Suburban Bus Division of the
Regional Transportation Authority

Addendum No. 3 is being issued to amend certain words, phrases, sentences or paragraphs for this solicitation for Fifteen-Passenger Paratransit Gasoline Buses. **Addendum No. 3 hereby replaces Addendum No. 2, Responses to Requests for Change or Approved Equal, Request No. 1.**

RESPONSES TO REQUESTS FOR CHANGE OR APPROVED EQUAL

"Attachment - B" sample floor plans

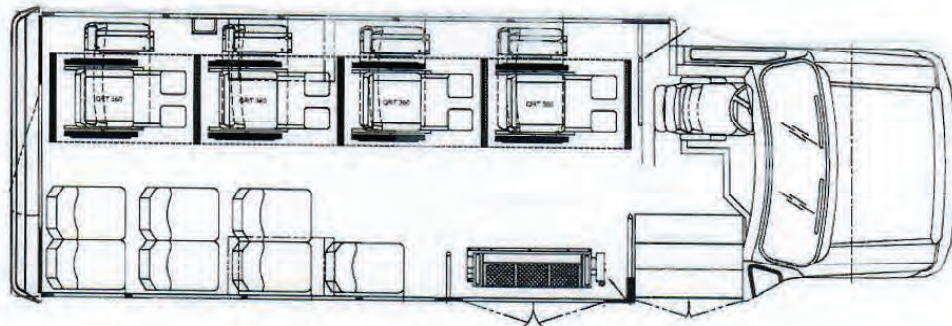
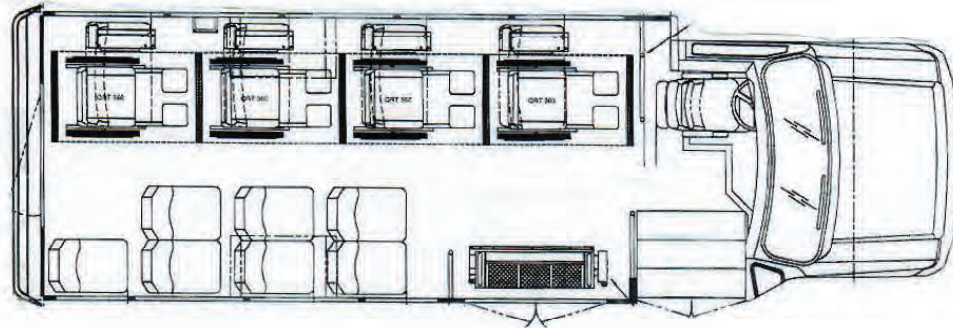
IFB No. 419986	Request #: <u>34</u>		
Solicitation Ref: <u>Exhibit D</u>		Page: <u>24</u>	Section: <u>TS 9.7 Passenger Seats</u>
Questions/Clarification or Approved Equal:			
Section states “All two passengers forward facing passenger seats must fold up and out of the way for passengers using mobility devices”. Mobility devices covers a wide range of equipment from wheelchairs to walkers/canes etc. Please clarify if in fact “all” two passenger seats must fold or are they just required in the locations where wheelchairs can be located/secured. This is important as there is a significant cost difference in fixed or foldaway seats.			
Attached (on the next page) is a representative floor plans (Attachment – B) that we feel meets the intent of the specifications as issued. All seats on right side are fixed type.			
Pace Response:			
ALL forward-facing passenger seats shall be the fold up type.			
The layout provided is unacceptable to Pace.

All seats on street side are foldaways while seats on curb side are fixed seats.
Previous Pace buses have fixed seats on curb side.

Seating layout will be finalized by Pace and the contractor during the pre-production period of the build.

"Attachment - A Lift Doors"

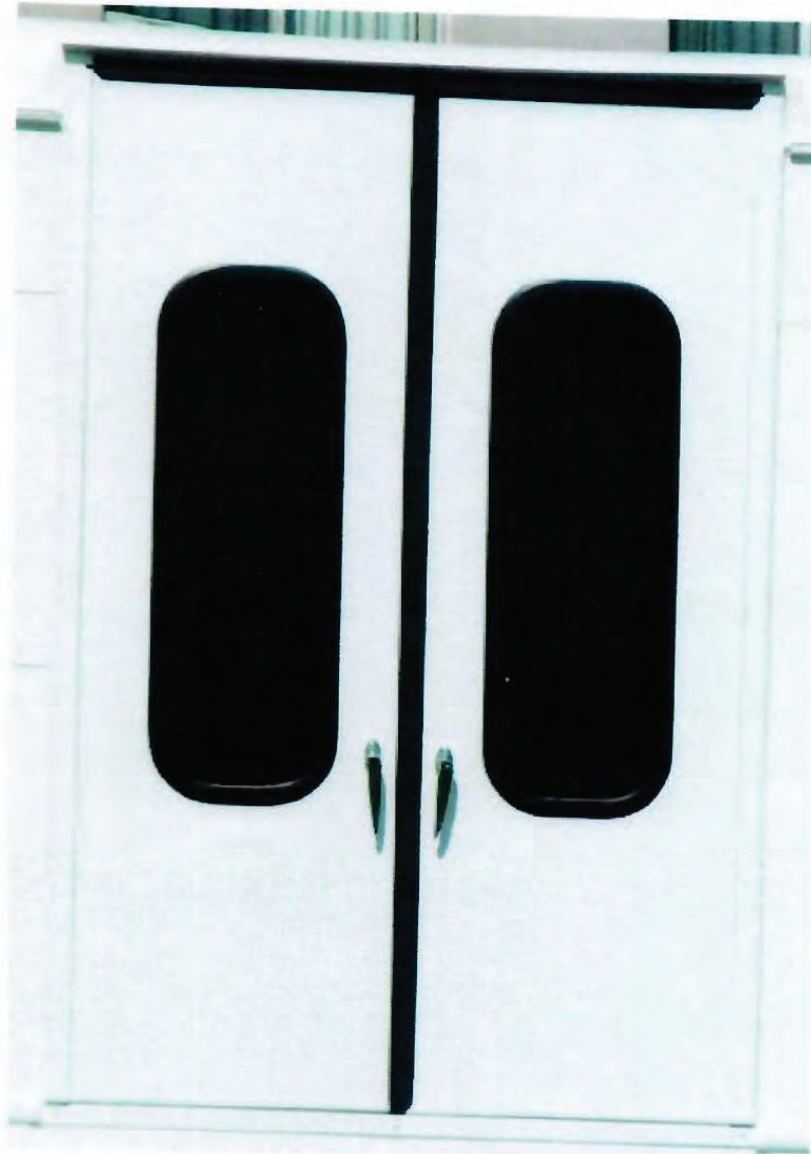
IFB No. 419986	Request #: <u>40</u>		
Solicitation Ref: <u>Exhibit D</u>		Page: <u>18</u>	Section: <u>TS 8.18 Passenger Doors</u>
Questions/Clarification or Approved Equal:			
Sections calls for wheelchair lift door to be one piece two panel fiberglass construction.			
Request approval of lift door that has a powder coated aluminum frame/structure with fiberglass overlay panels that. totally enclose the framing structure. See “Attachment – A Lift Door” (on next page)			
Pace Response:			
Insufficient information has been provided to approve the door design in the request.			
Please provide complete assembly and process drawing for the assembly and manufacture of the door.

DRAWING NAME: FRONT LEAF LIFT DOOR
 DRAWING NUMBER: 2614180
 MATERIAL: FLAT FLOOR
 ASSEMBLY

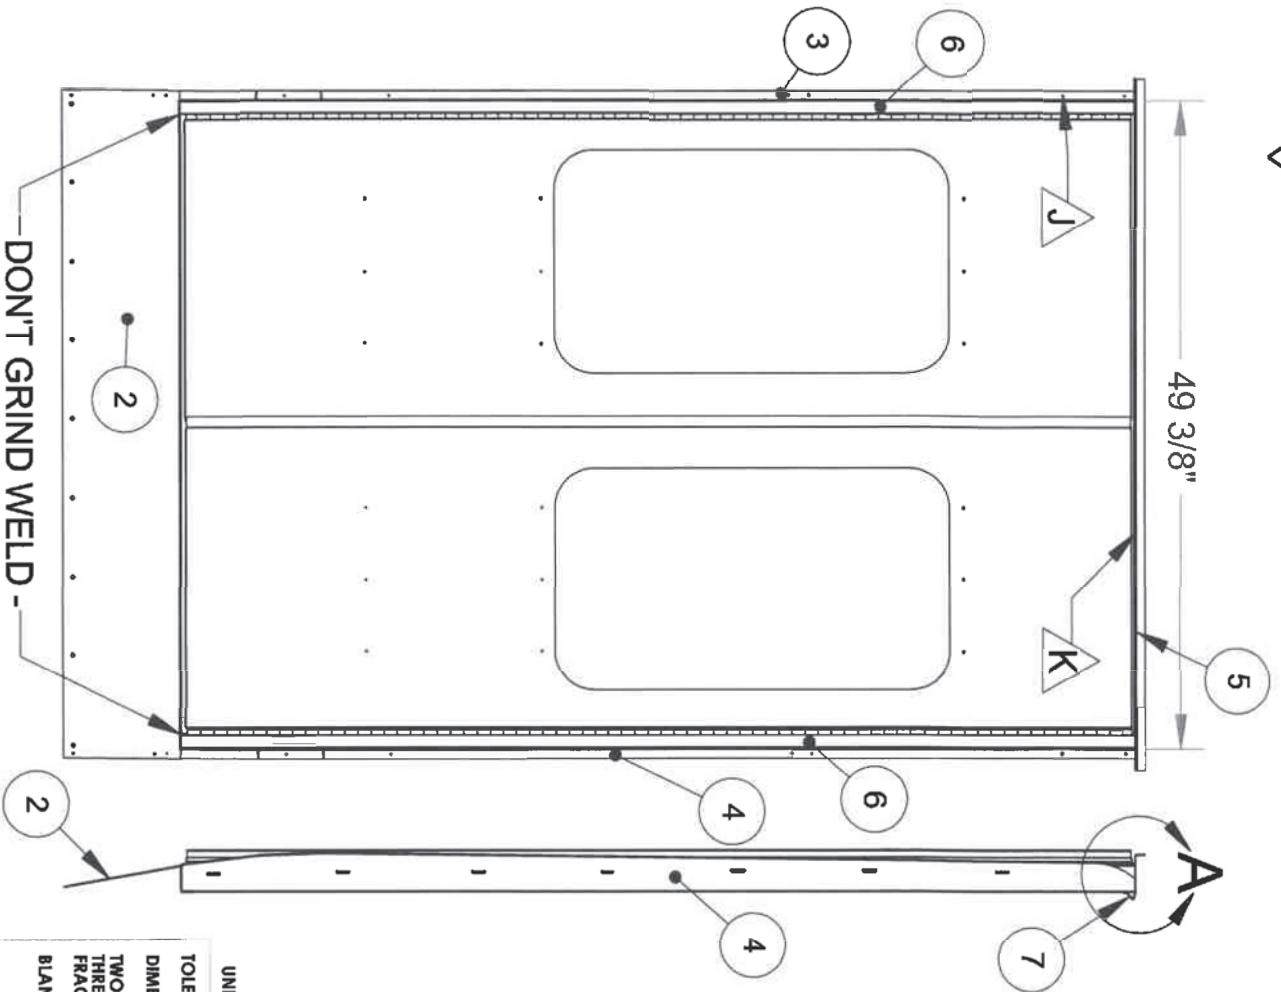
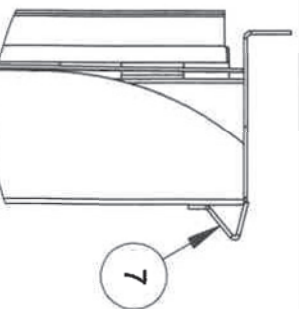
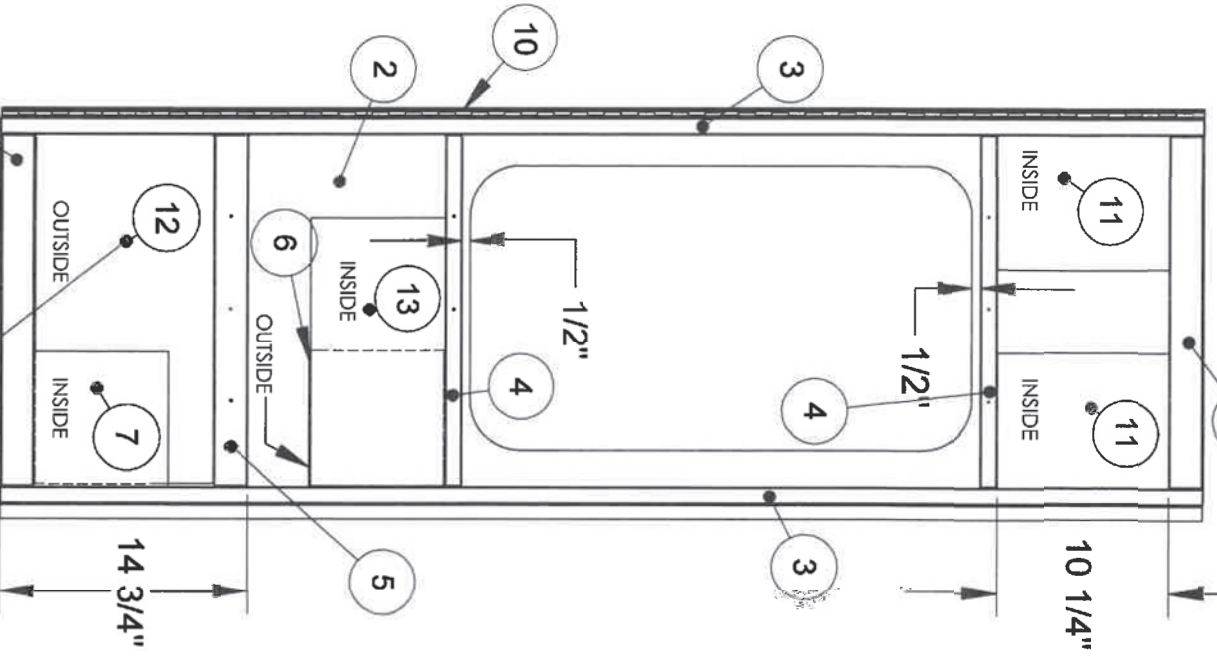
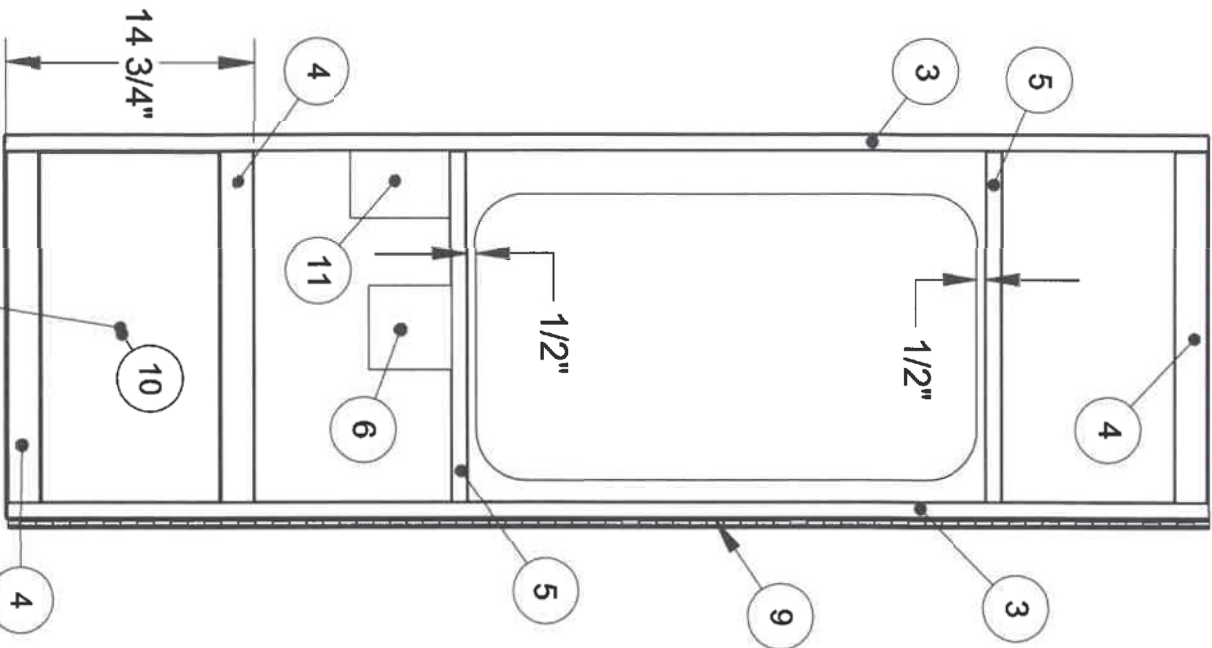
IFB No. 419986	Request #: 34		
Solicitation Ref: Exhibit D	Page: 18	Section: TS 8.18 Materials	
Questions/Clarification or Approved Equal:			
Per Pace’s response to our Lift door question during round 1, we’ve attached structural drawings and			
process documents for our standard lift door. This door is in service by large urban transit authorities			
throughout the Northeast without problem.			
Pace Response:			
Clarification as requested.			
Pace accepts the proposed doors.

EXHIBIT "A"

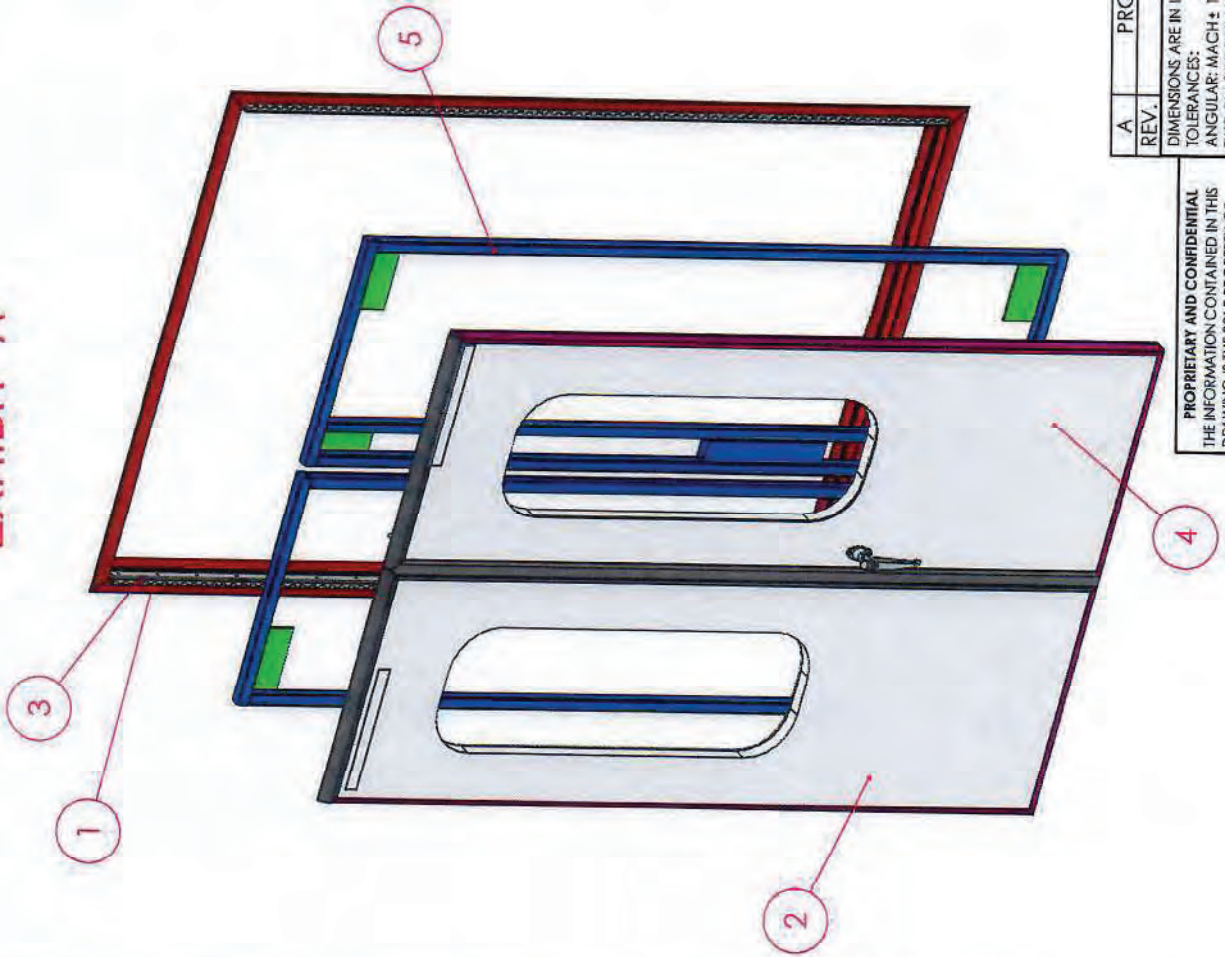
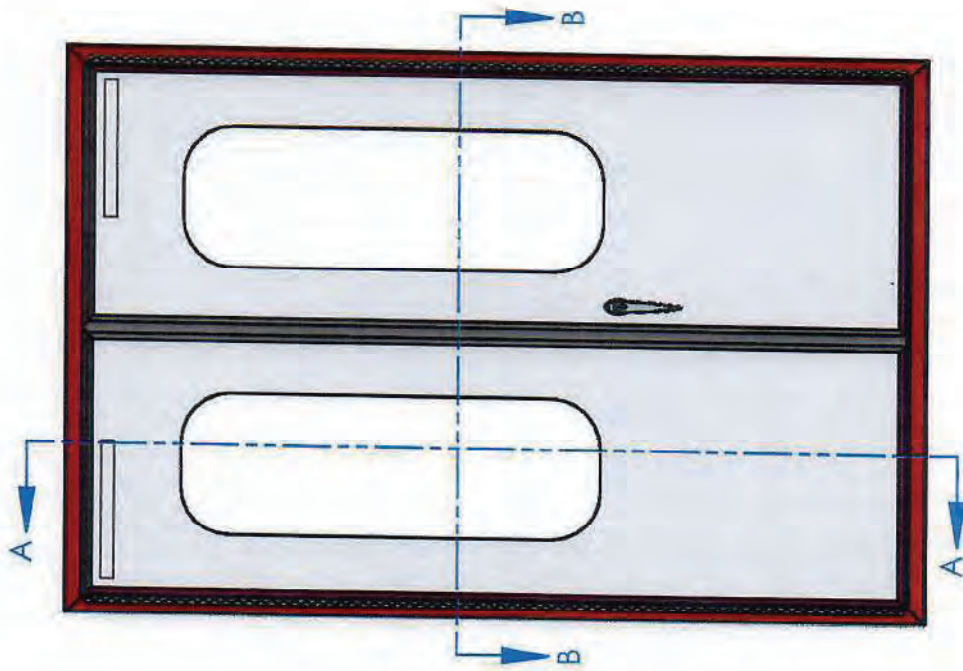
IFB No. 419986	Request #: <u> 9 </u>		
Solicitation Ref: <u> Exh. D </u>	Page: <u> 18 </u>	Section: <u> </u> TS 8.18 Lift Door <u> </u>	
Questions/Clarification or Approved Equal:			
We hereby request approval of our lift door that is manufactured by Challenger Door. This door is			
widely used in transit bus application as well as other commercial uses. There are thousands of these			
doors in use daily with proven reliability. Door is corrosion resistant, well insulated and meets any			
FMVSS, ADA or NHTSA applicable requirements. See "EXHIBIT A" attached.			
Pace Response:			
Accepted.
